SB, Update information, K770 II, 2026-03

SYMPTOM/DESCRIPTION

K 770 II, a new updated version of the K 770, has been launched. **The carburettor and cylinder assembly on this K 770 II differ from those used on previous models (NOT backwards compatible).** The purpose of this Service Bulletin is to clarify the compatibility of parts based on the respective machine models.

Marking applied in area according to view below:

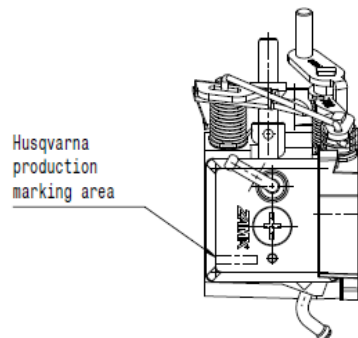
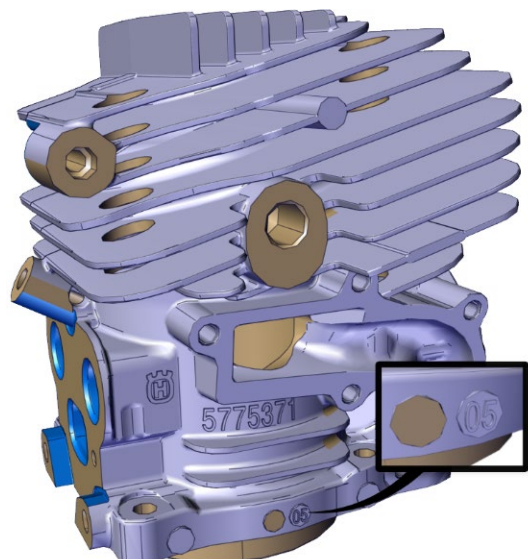
The carburettor used on the K 770 II (part number 596 87 56-03) will feature a green identification marking. This marking is intended to distinguish the adjusted carburettor installed on the K 770 II from the carburettor used on the existing K 770 models, which does not carry this marking.

Color: green
Thickness: 1.5mm min.
Length of marking: 5mm min.

The new **K 770 II Cylinder Assembly (Part No. 581476105)** will bear the marking **“05”** to distinguish it from the existing **K770 Cylinder Assembly (Part No. 581476104)**, which will instead bear the marking **“03”**.

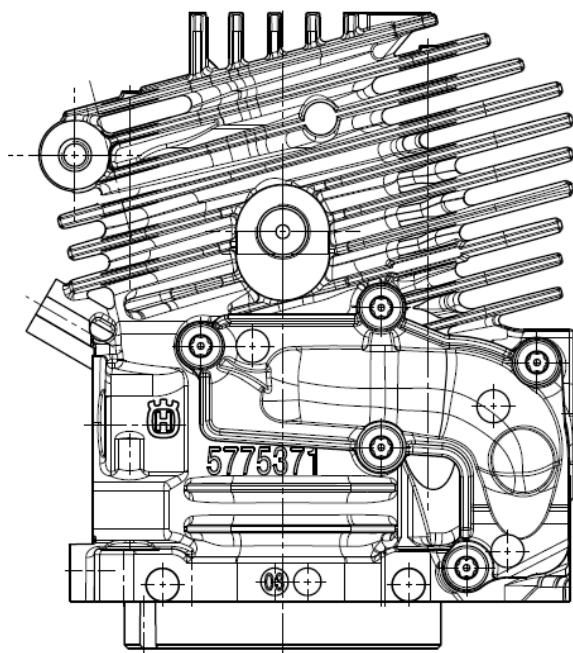
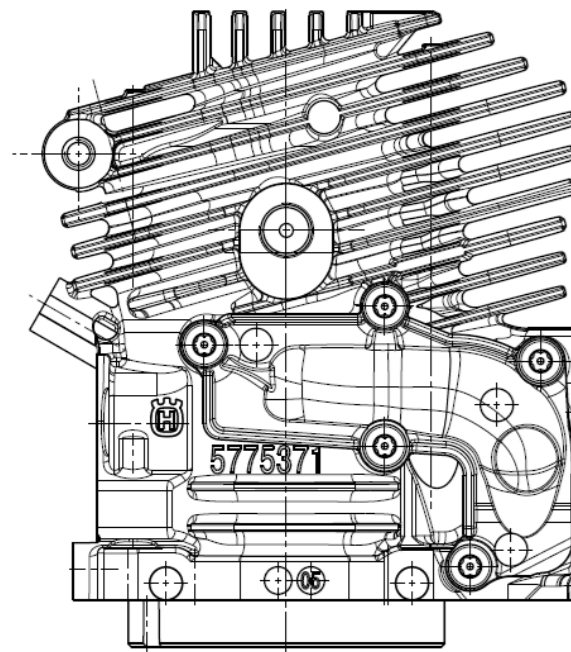
581476104 Cylinder Assy K 770

Assy marking view
Var 03

581476105 Cylinder Assy K 770 II

Assy marking view
Var 05
